ADDENDUM NO. 2

KALAMAZOO PUBLIC SCHOOLS – CENTRAL HIGH SCHOOL PIPING REPLACEMENT

ADDENDUM NO. 1

DATE OF ISSUANCE: February 17, 2020
PROJECT: Kalamazoo Central High School Piping Replacement
Kalamazoo, MI
OWNER: Kalamazoo Public Schools
ARCHITECT'S PROJECT NO.: 18-537
ORIGINAL BID ISSUE DATE: December 18, 2019

ADD-1 Item No. D-3 - Existing Copper Pipe to Remain

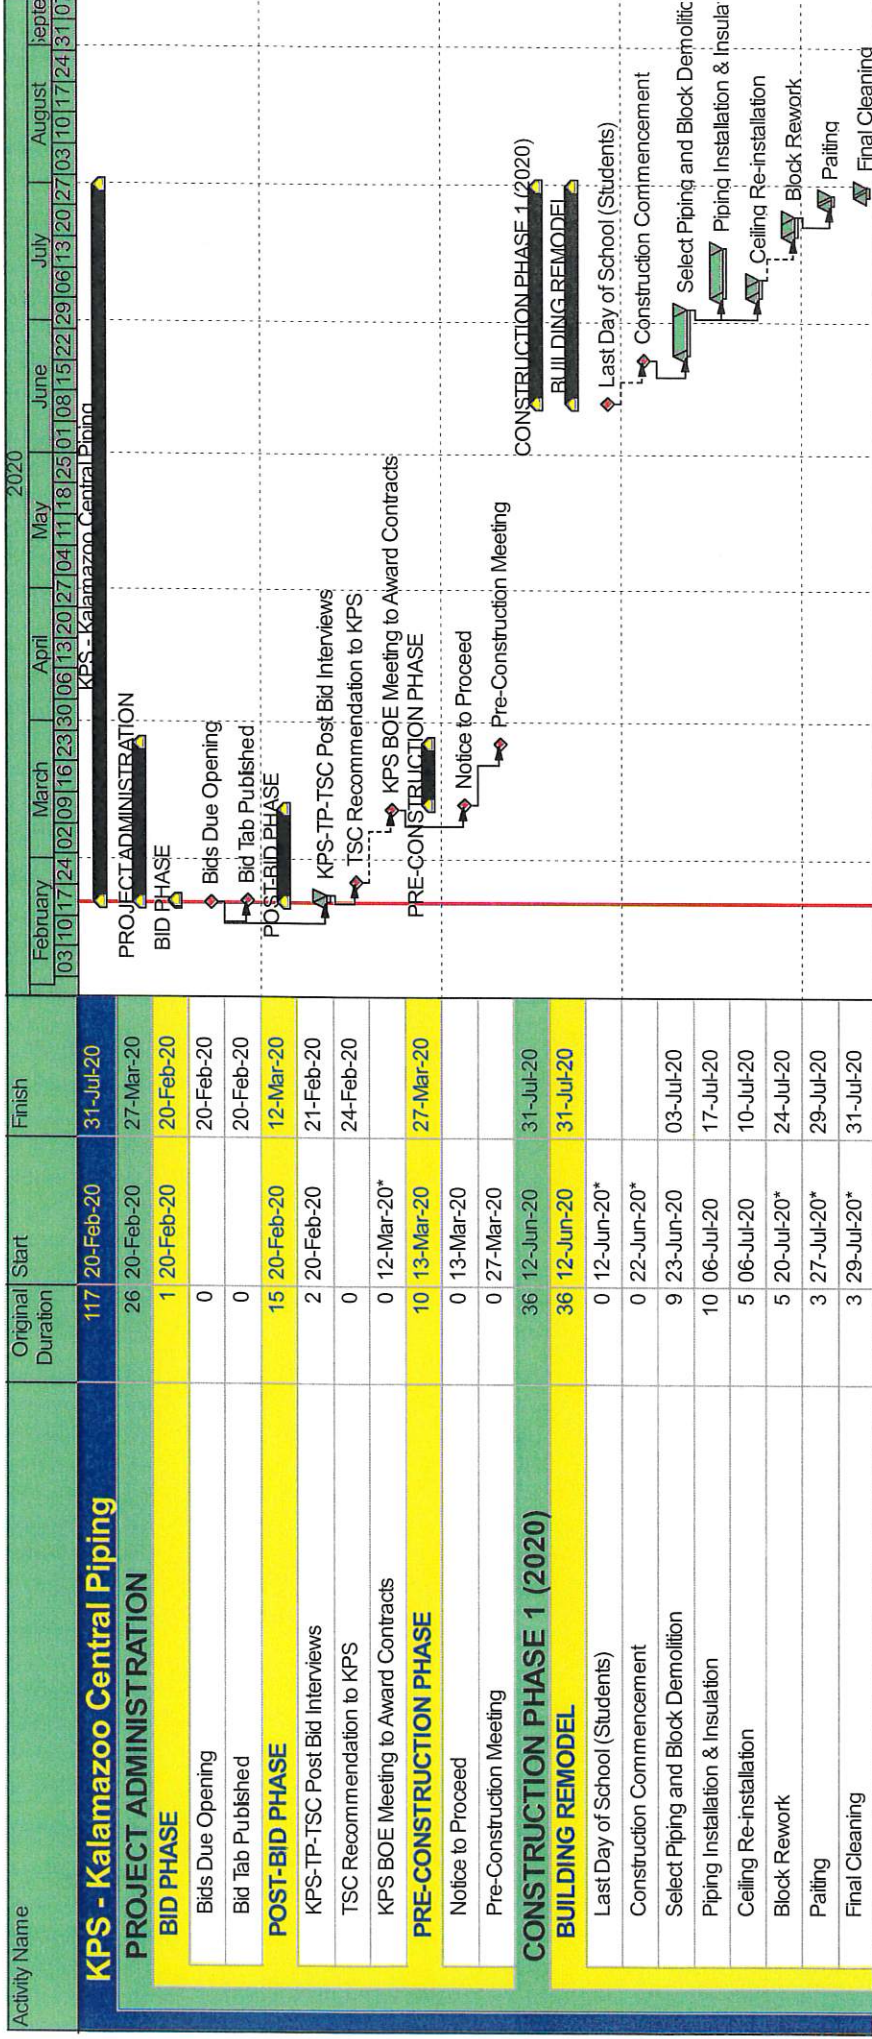
Refer to Sheet: P102F and the attached photos.

An approximate 20' length of the 1-1/4" HW and 2" CW feeding the South end of the Men's Locker was replaced with copper pipe in 2018. At the contractors option this piping may be reused OR replaced with new. Note that this piping is currently installed in Storage 709 where no ceiling exists.

The HRW piping shall be replaced as indicated however it shall be located in 709 Storage.
